WATERBURY FILING NO. 1
GRADING EROSION CONTROL PLAN
INITIAL EROSION CONTROL PLAN 2

GRADING EROSION & STORMWATER CONTROL PLAN
INTERIM EROSION CONTROL PLAN 2

WATERBURY FILING NO. 1

POND 2 PERMANENT FOREBAY DETAIL PHASE 1
SCALE: 1"=5'

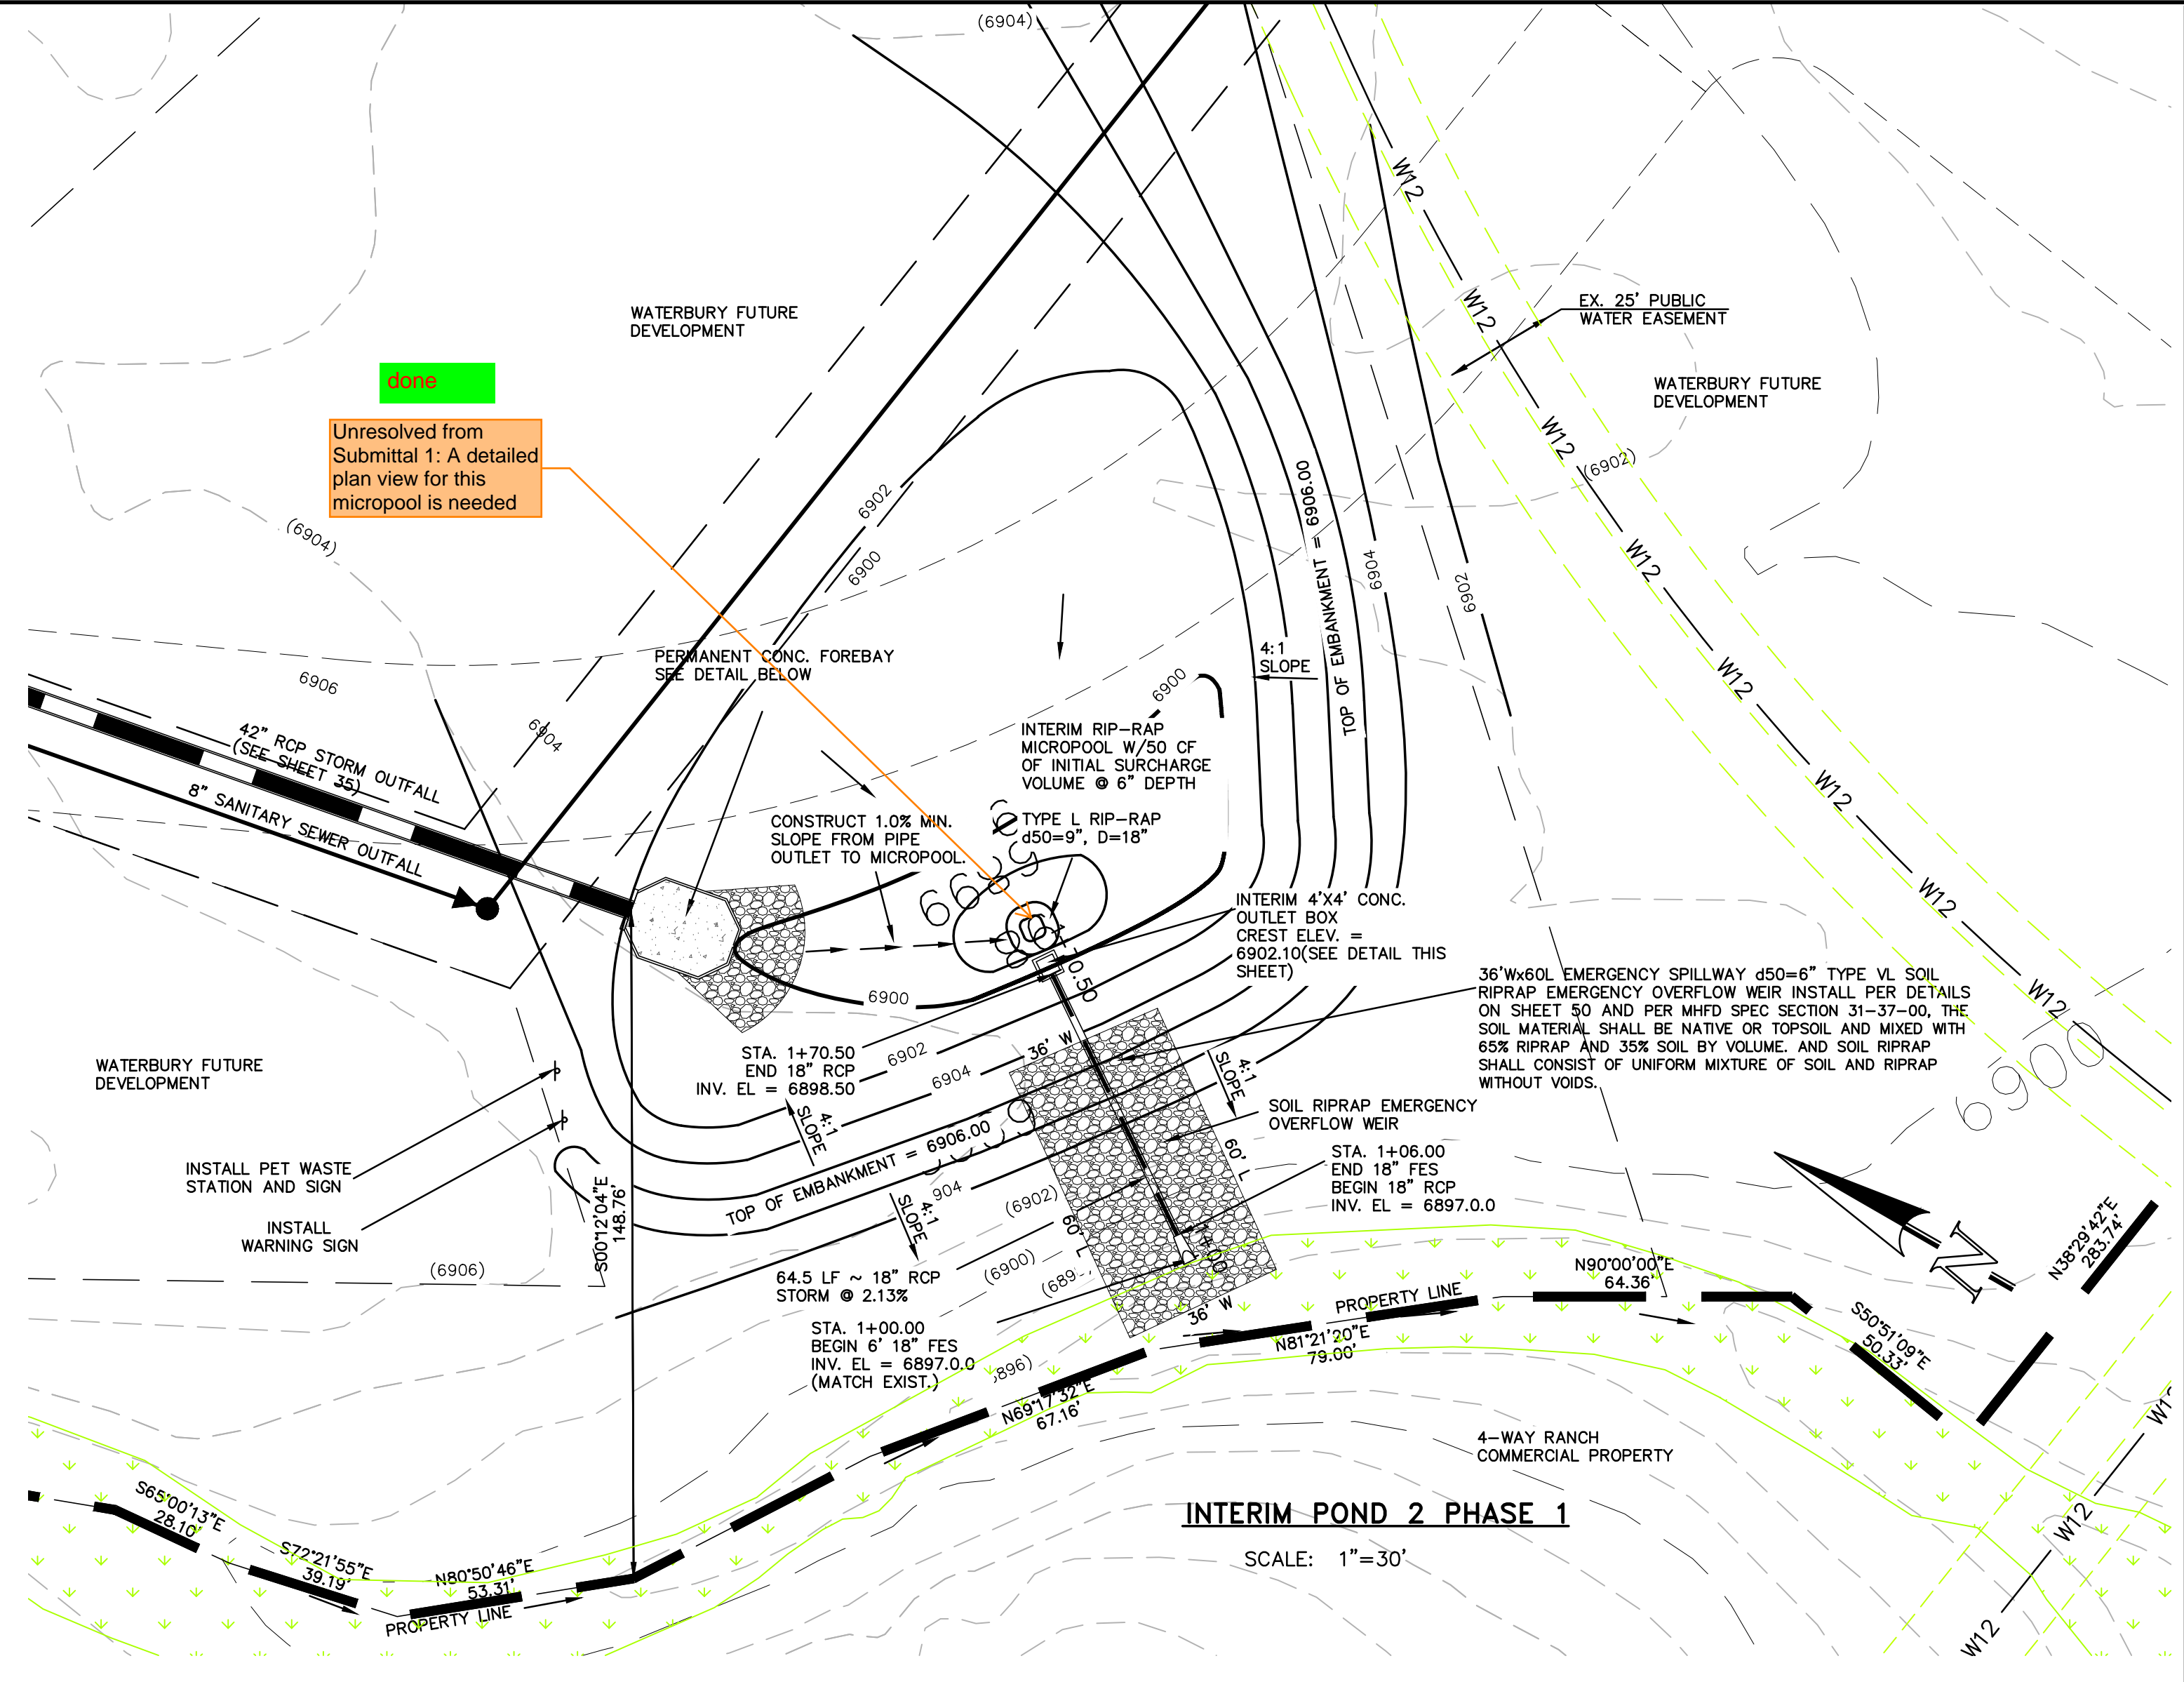
What are the dimensions of this micropool? It appears to have some bottom width and then it goes up in elevation. Clarify and fully show micropool.

NORTH CONCRETE FOREBAY PHASE 2
SCALE: 1"=10'

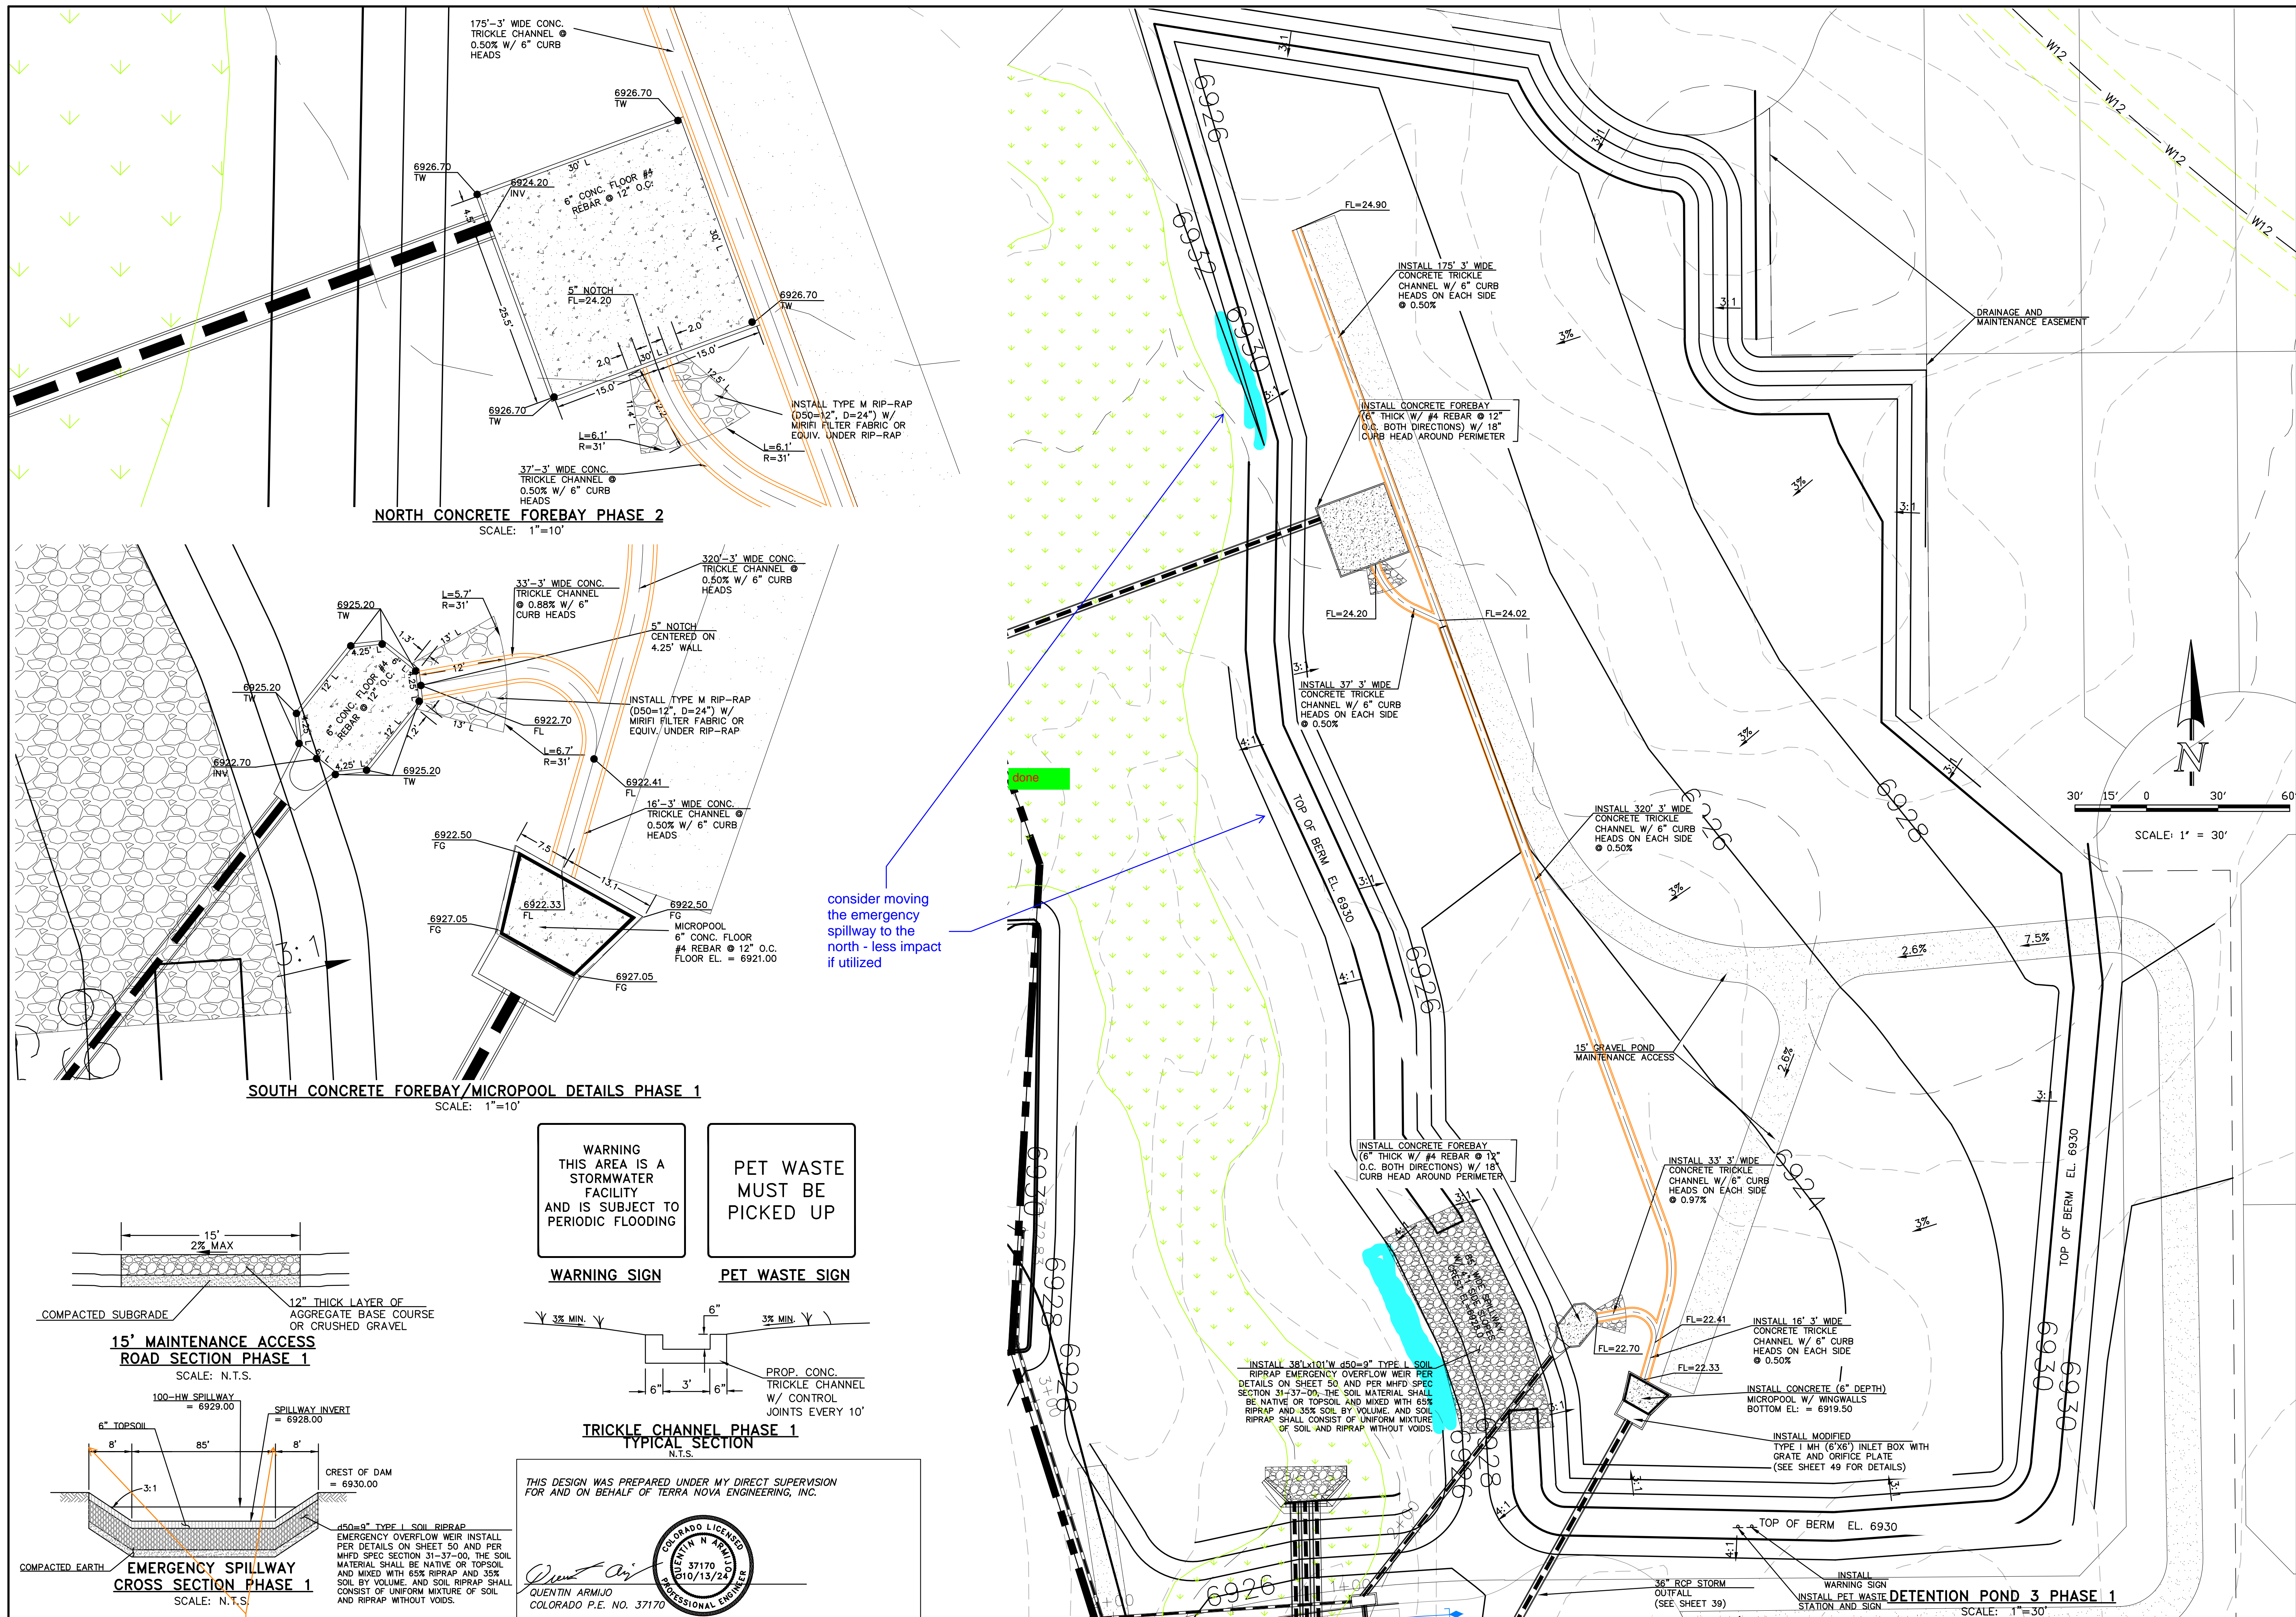
Unresolved from Submittal 1: with 2ft elevation change and 3:1 slopes, these should be 6ft

REVISED TO 4:1

WATERBURY FILING NO. 1
CONSTRUCTION SET
WEST CHANNEL - CHANNEL IMPROVEMENTS PLAN

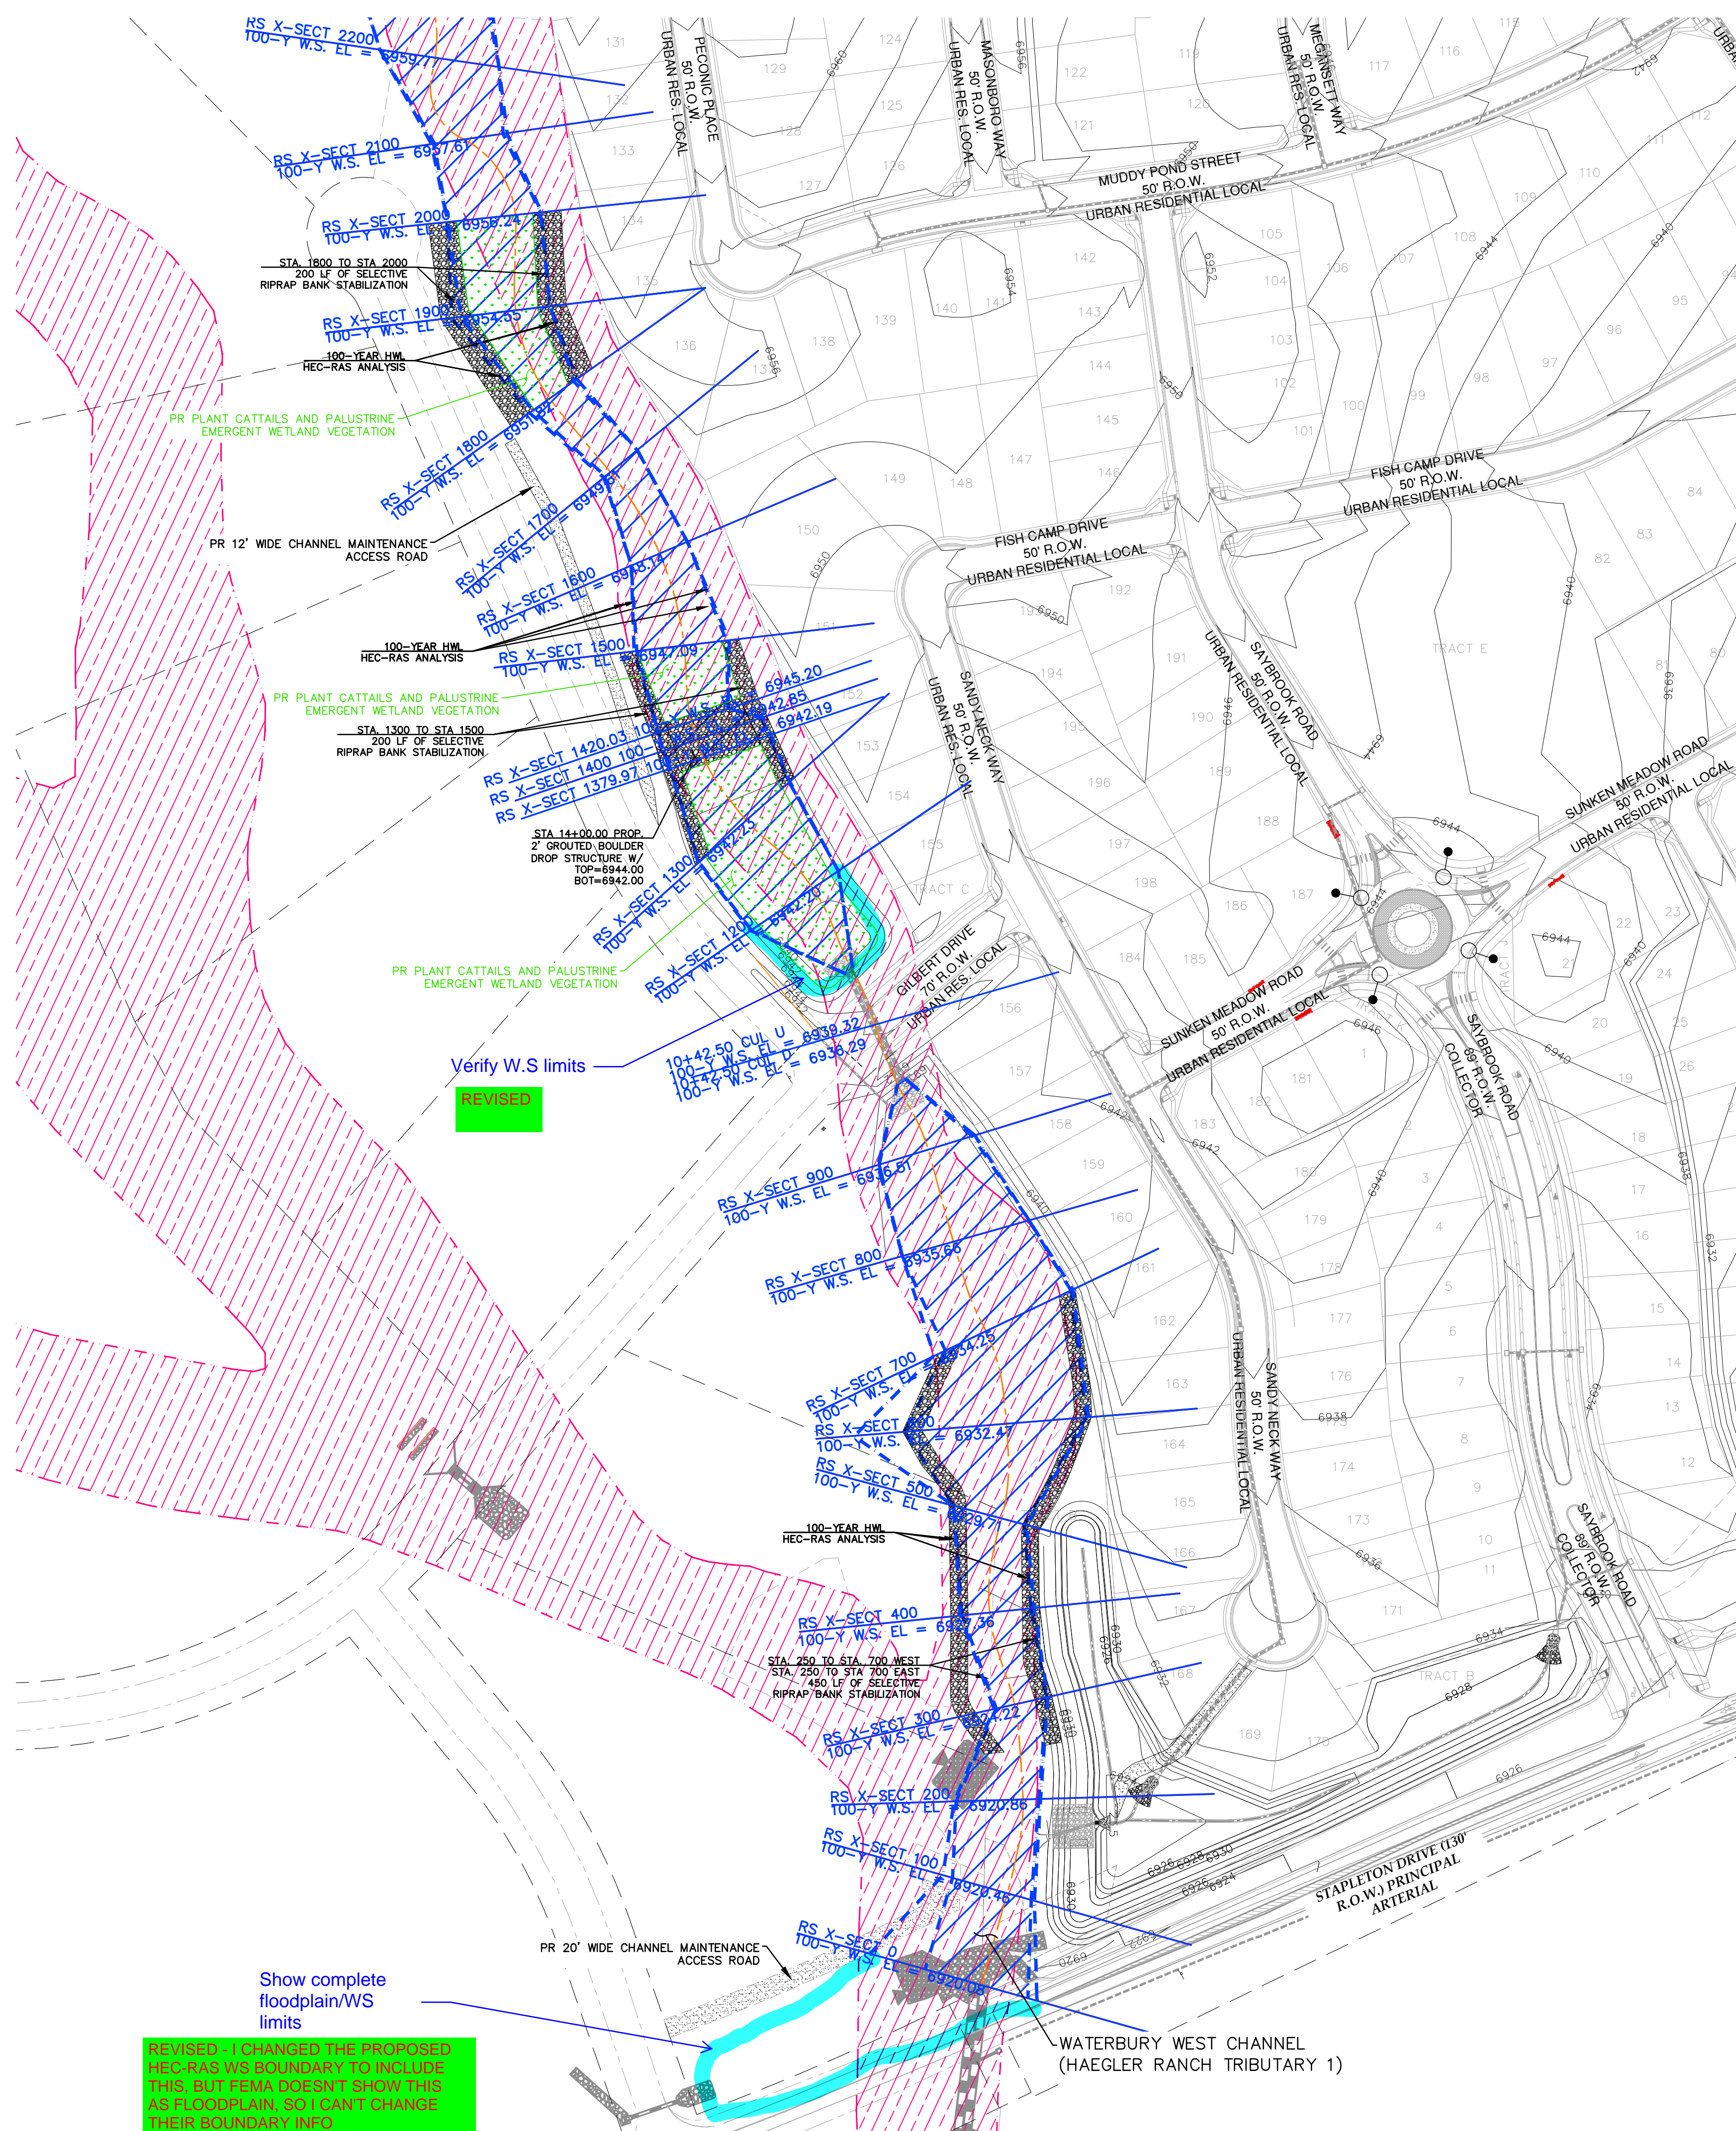
REVISED: I CHANGED THE PROPOSED W.S. AND HIS BOUNDARY TO INCLUDE THIS, BUT TERRA DOESN'T SHOW THIS AS FLOODPLAIN, SO I CAN'T CHANGE THEIR BOUNDARY INFO

Verify W.S limits
REVISED

Provide a legend
DONE
